FRONT SUSPENSION POPPING NOISE WHILE TURNING RIGHT OR LEFT—VEHICLES BUILT BEFORE 4/8/2005

TSB 05-9-11

FORD:
2005 Mustang

Figure 1 - Article 05-9-11

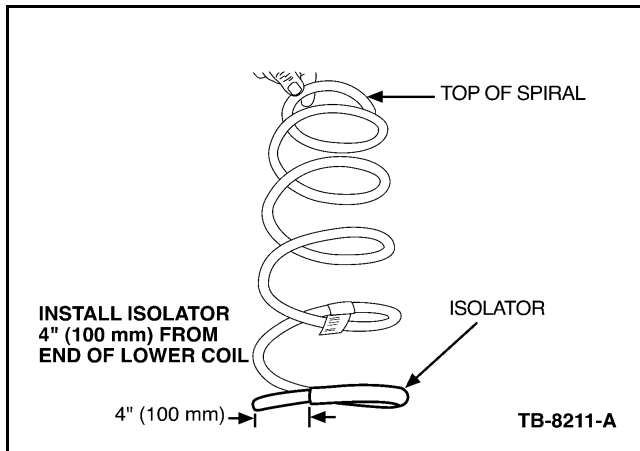
Some 2005 Mustang vehicles built before 4/8/2005 may exhibit an intermittent popping noise from the front of the vehicle while turning left or right. The noise will typically occur during low speed maneuvers and may occur multiple times while turning.

1. Remove the strut and spring assembly. Refer to Workshop Manual Section 204-01.
2. Disassemble the strut and spring assembly.
3. If the springs do not have a rubber isolator on the bottom spring coil, install isolators. Clean off any dirt prior to installing the isolator. The isolator should be installed 4" (100 mm) from the end of the coil (Figure 1).
